Case No: 15/01495/S73 (RENEWAL OF CONSENT/VARY CONDITIONS)

Proposal: VARIATION OF APPLICATION 1101924FUL TO ALTER LAYOUT INCLUDING HOUSE POSITIONS AND FLOOR LEVELS, DELETE LANDSCAPING TO SIDE OF ENTRANCE ROAD, REDUCE VERGE WIDTH AND ADD HARD PAVING AND RETAINING WALLS. DELETE HARD PAVING TO NO DIG FOOTWAY. REVISE POSITIONS OF GAS TANKS AND ERECT ENCLOSURES OVER 2M HIGH EITHER SIDE OF ENTRANCE ROAD.

Location: LAND SOUTH WEST OF THE STABLES MAIN STREET UPTON PE28 5YB

RECOMMENDATION - APPROVE

SITE WORKS 1

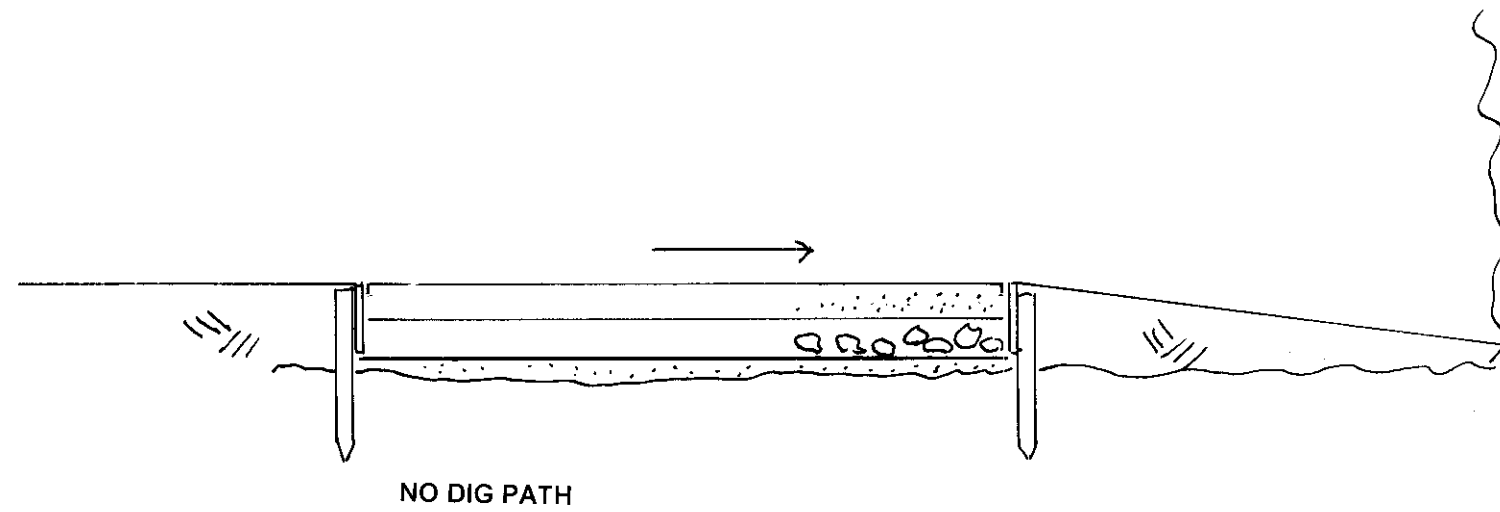
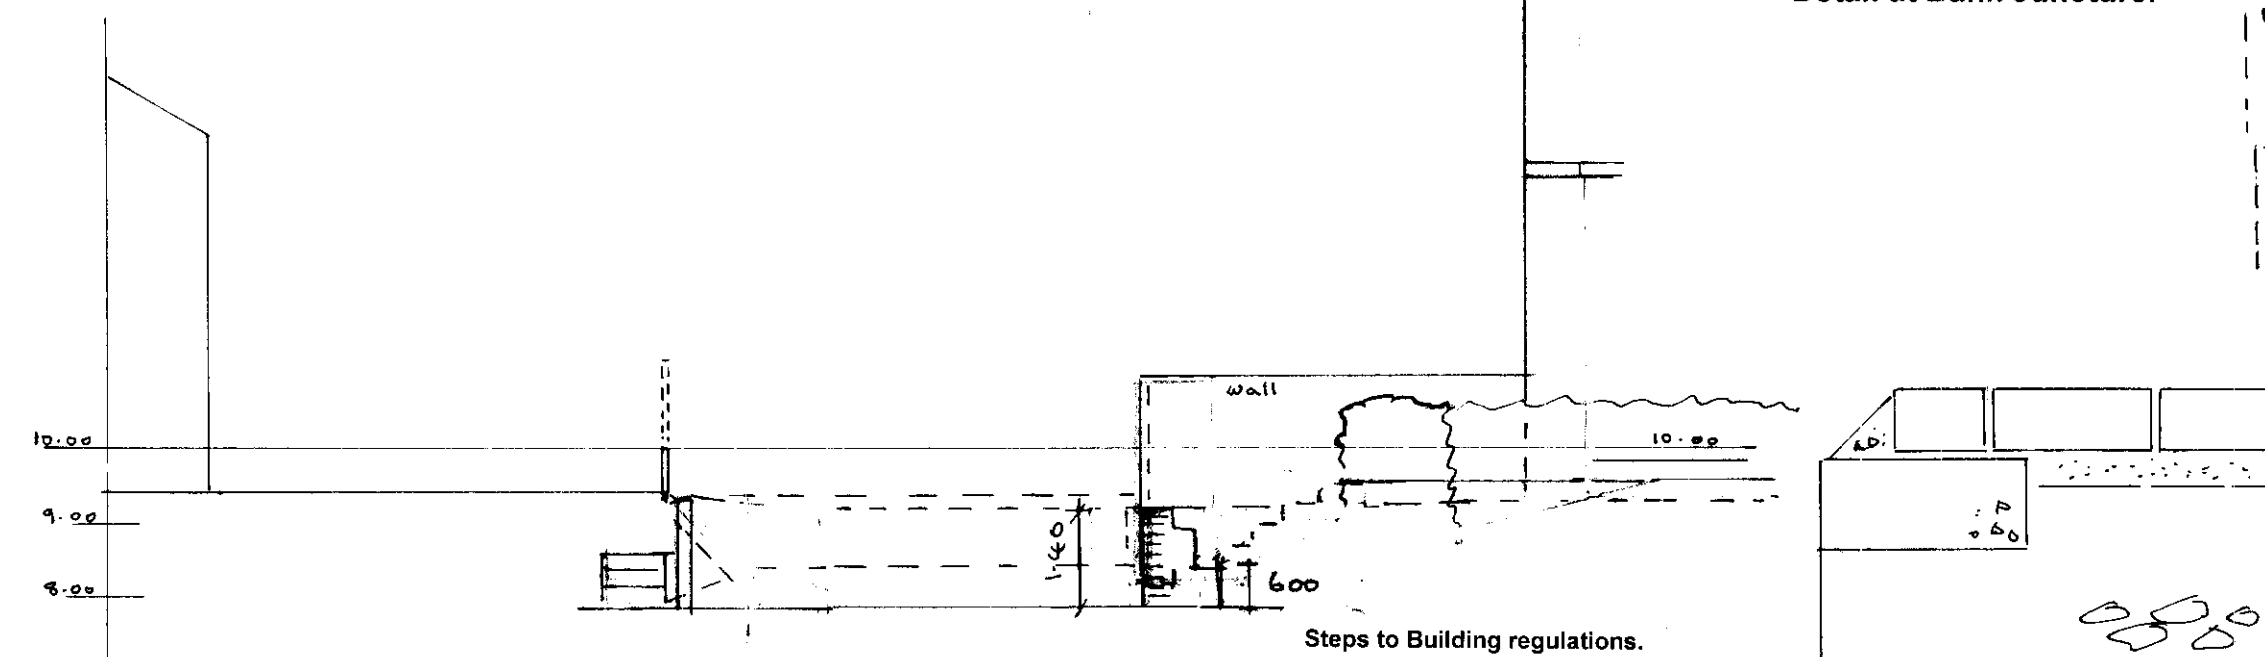
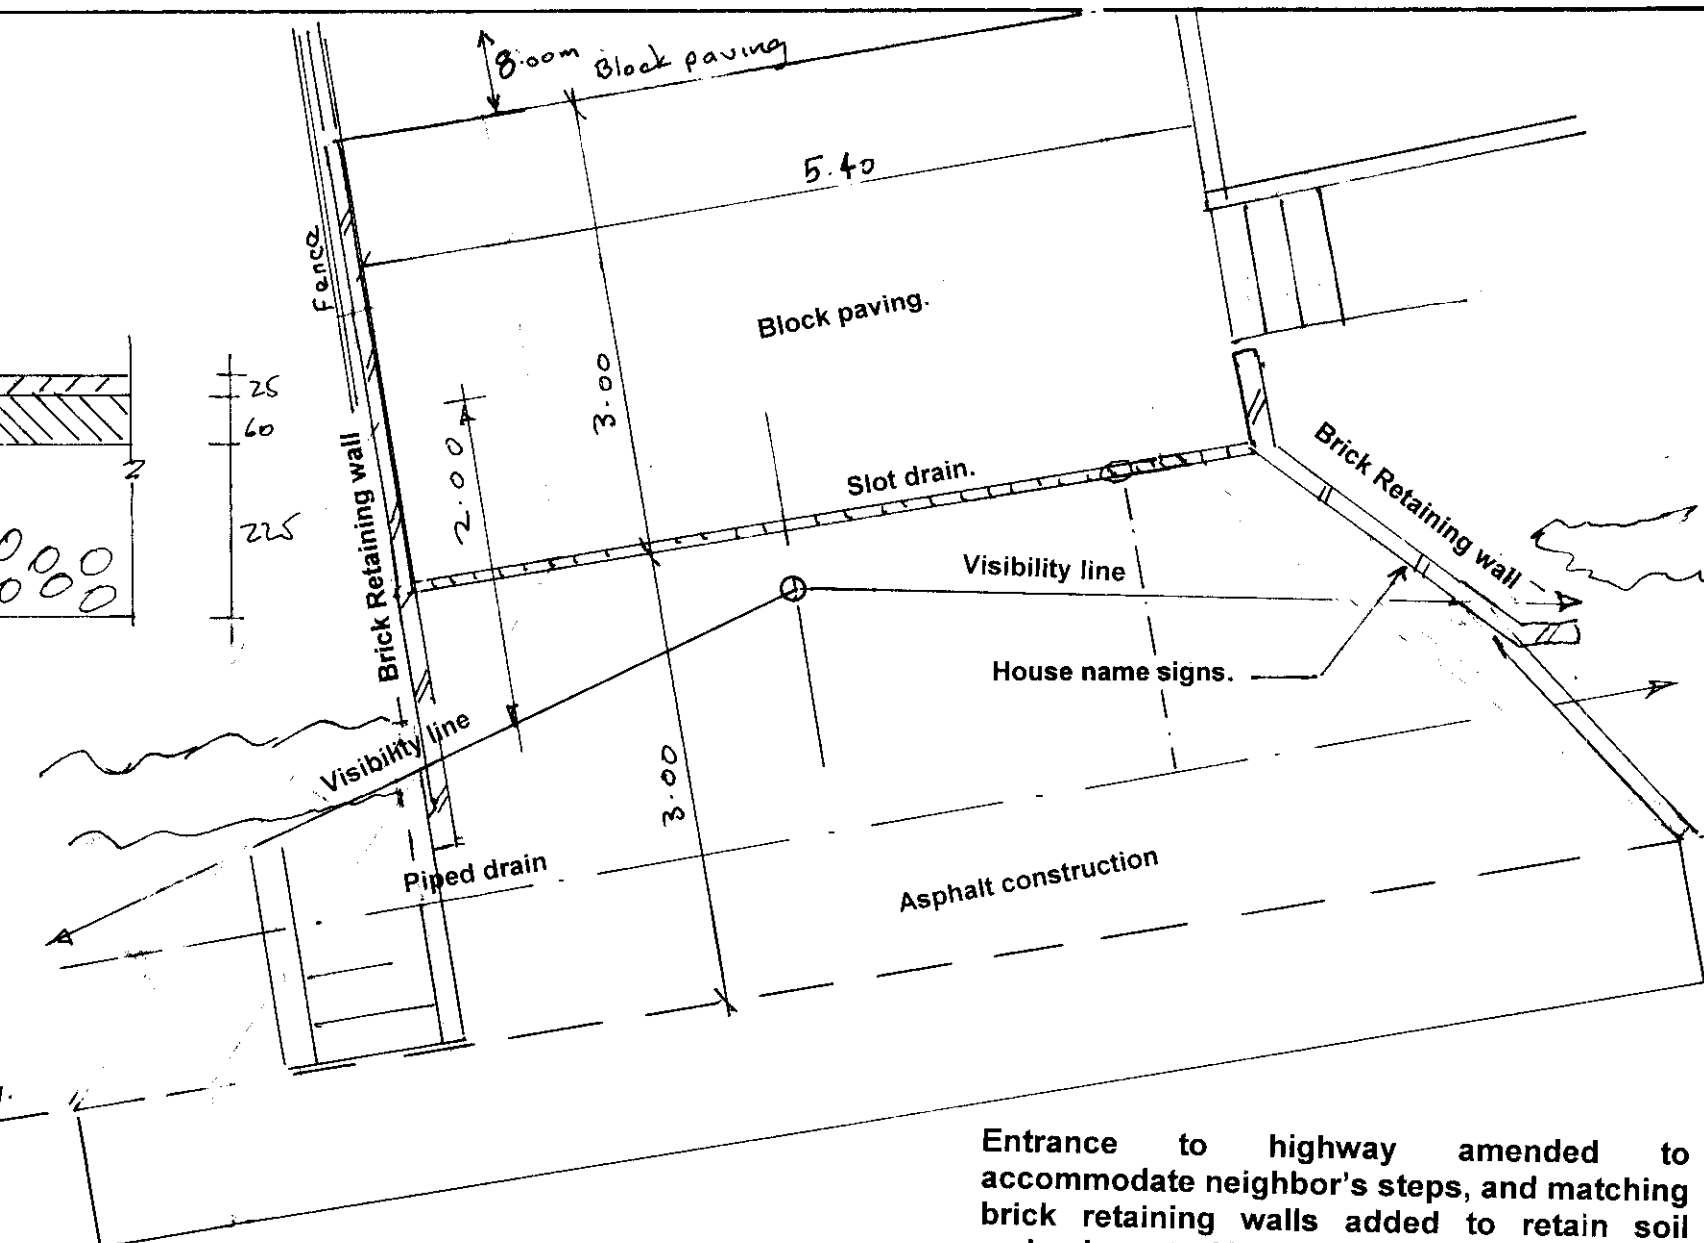
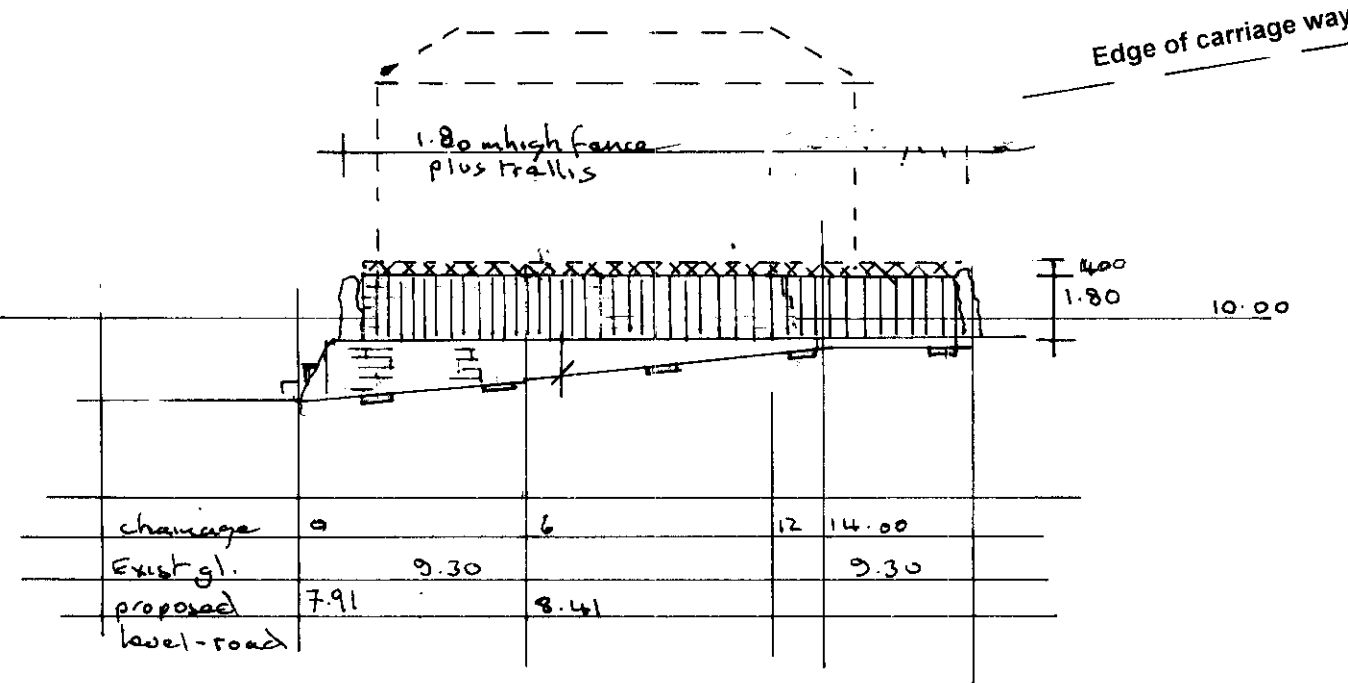
Amendments.
Driveway entrance realigned.
Landscaping to side of entrance road deleted.
Verge width reduced and hard paved.
Non dig front path surface amended to pea gravel. Disabled access via rear driveway.

Entrance to highway amended to accommodate neighbor's steps, and matching brick retaining walls added to retain soil embankment. Visibility lines retained and maintained.

SITE WORKS 2

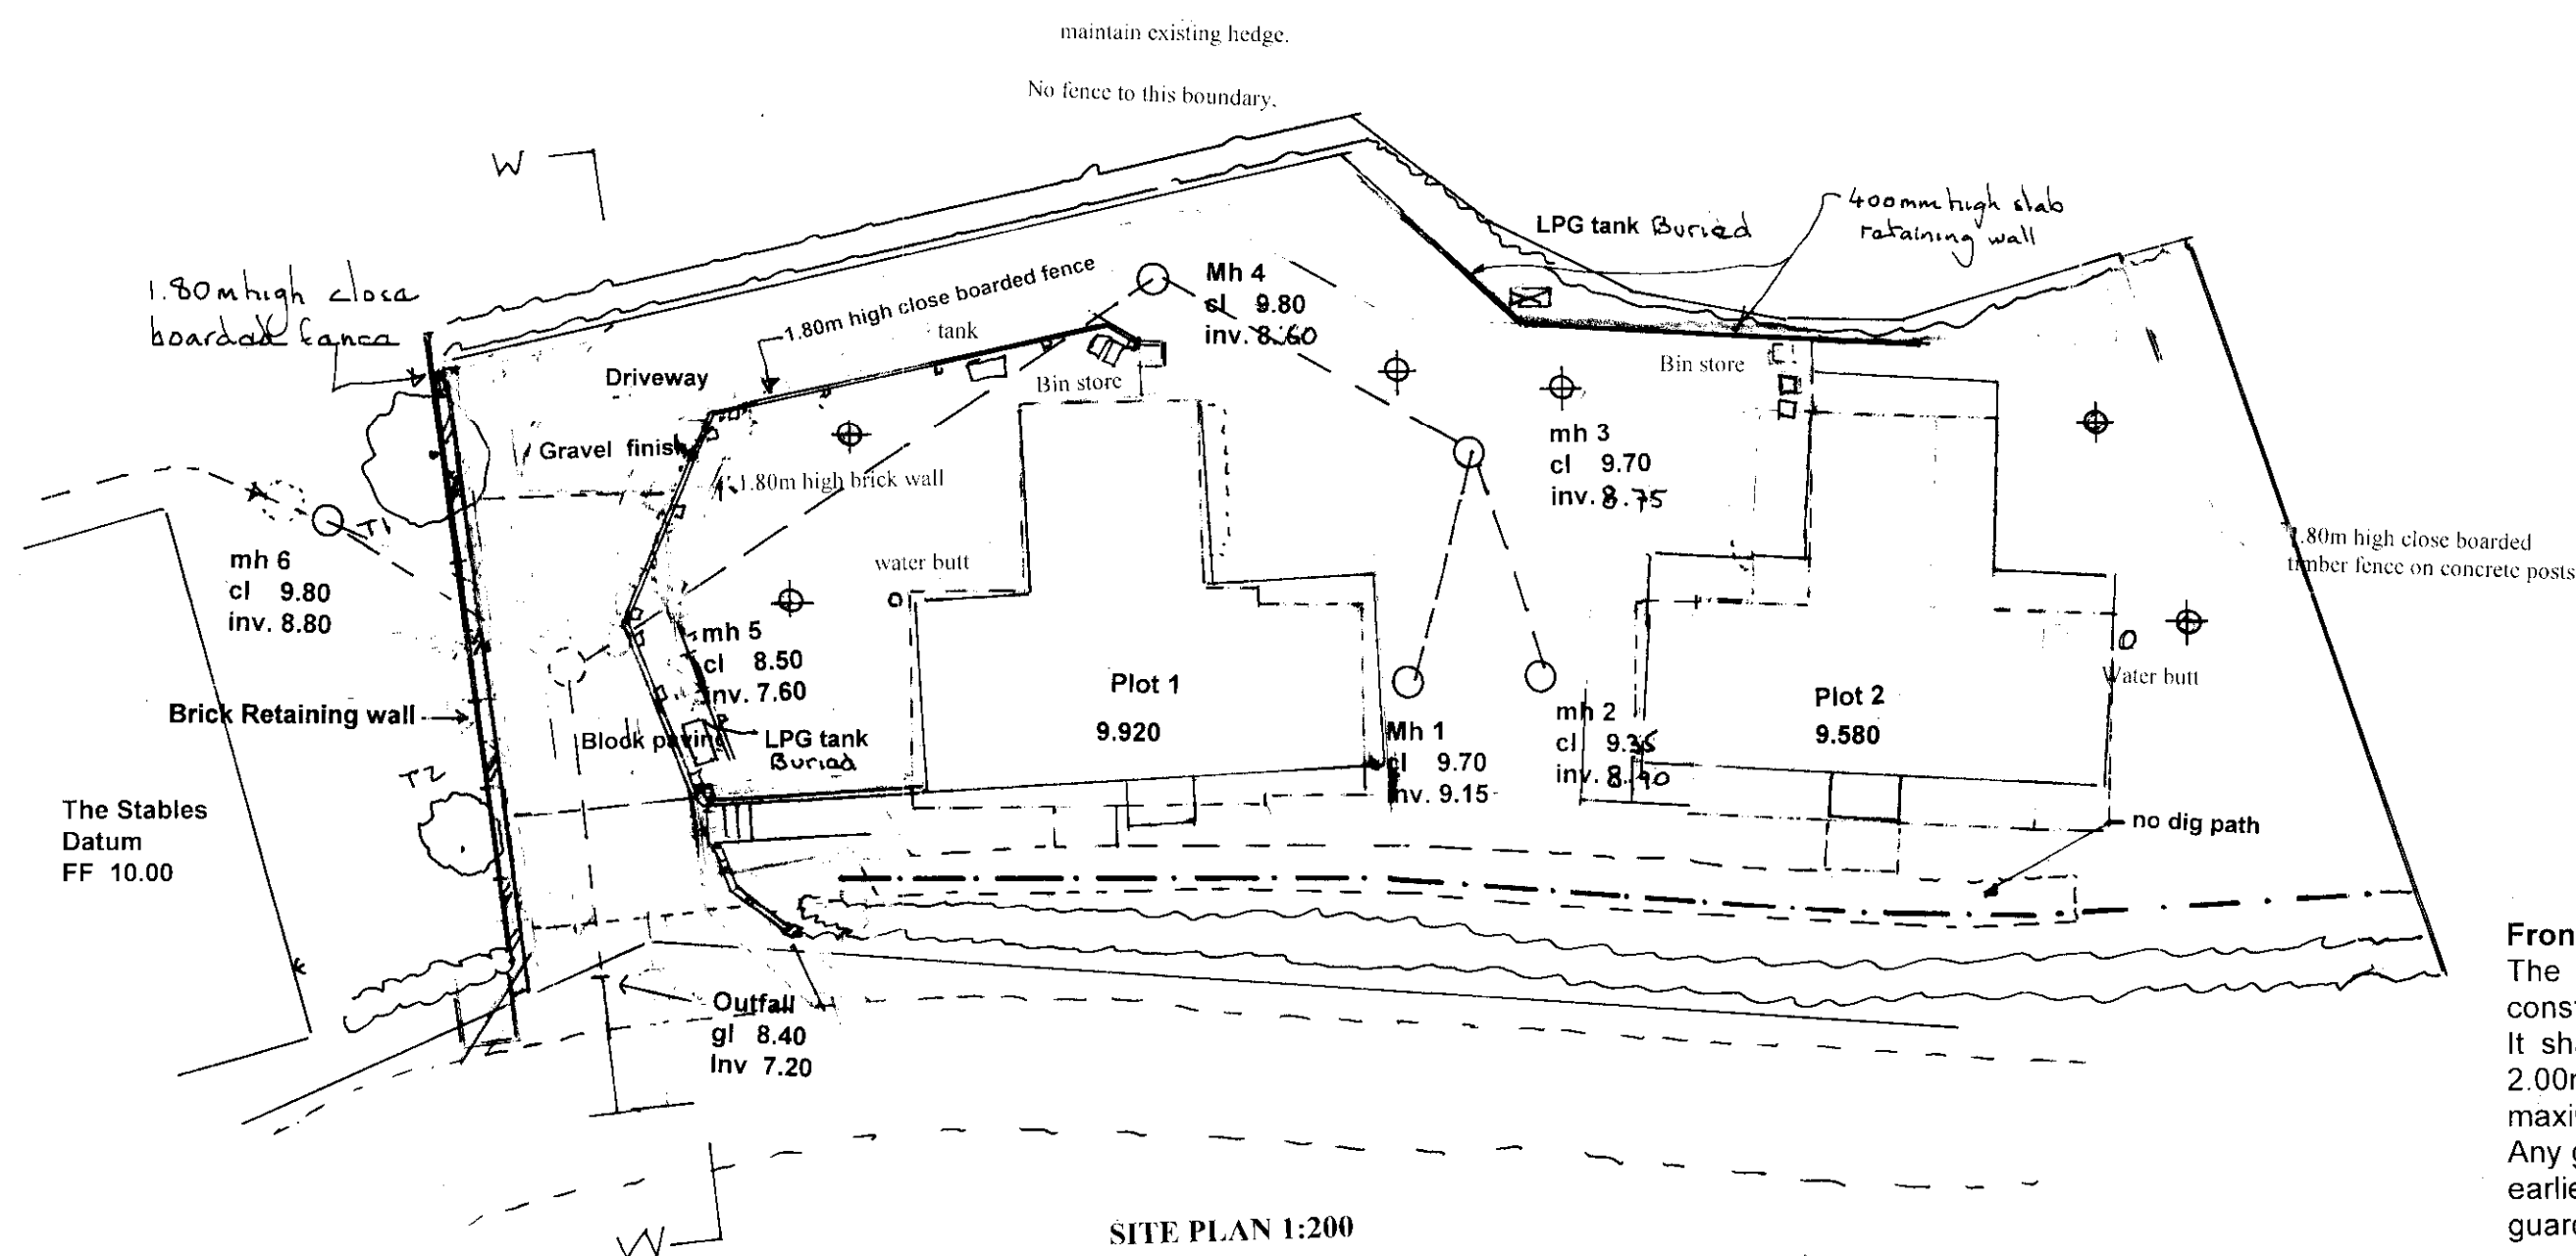
House positions amended to as built.

FENCE AMENDED.

As Built and Proposed Final Changes.

Minor changes to house positions, and minor changes to floor levels, Plot 1 finished floor level increase from 9.850 to 9.920m an increase of 70mm, and Plot 2 increase from 9.550 to 9.580m an increase of 30mm.
Delete landscaping to side of entrance road, reduce verge width and add hard paving.
Delete hard paving to no dig footway.
Revise positions of gas tanks.
Erect enclosures to entrance road over 2.00m in height.
Small retaining wall to end of hedge at roadway/drive entrance.

1.80m High close boarded fence for complete length topped with 400mm high trellis. Fence painted green Cuprinol "Seagrass".

Boundary Wall to Plot 1
Matching Brick to houses with red brick engineering brick coping, 1.80m high above plot 1 ground level, 1.80 to 2.85m high on driveway side. 2 Courses red engineering brick dpc. Matching brick retaining wall to main entrance by roadway to hedge end.
